■ MUD GUARD

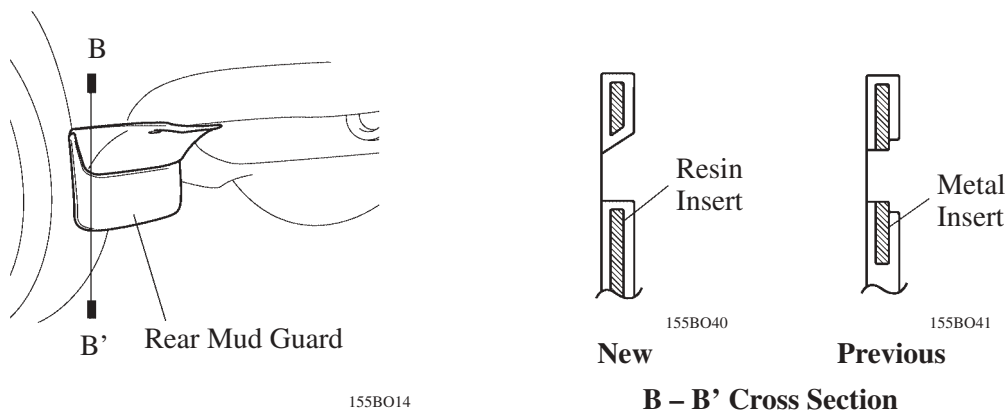
The material of both the front and rear mud guard inserts has been changed from metal to resin for weight reduction and improved corrosion resistance.

■ TAILGATE STOPPER

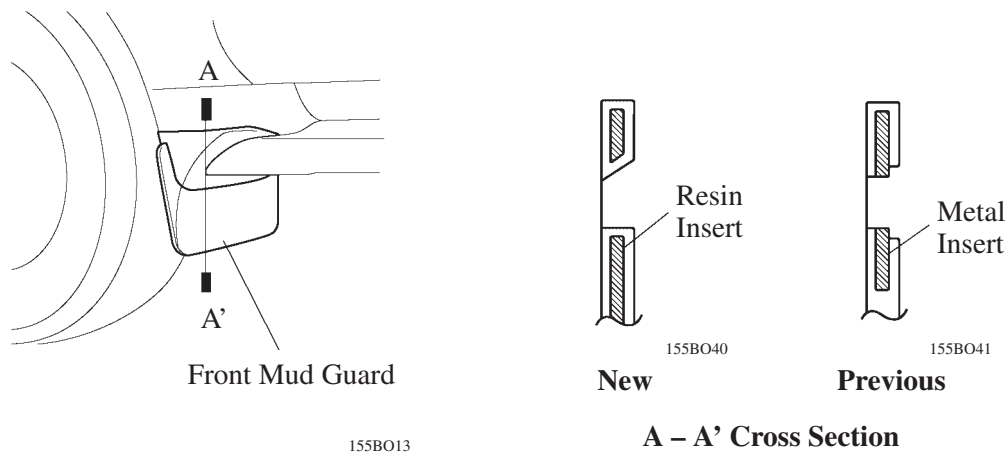
The tailgate stopper has been changed from the folding-arm type to the cable type and a torsion bar has been provided inside the tailgate. As a result, the tailgate can be opened and closed more smoothly.
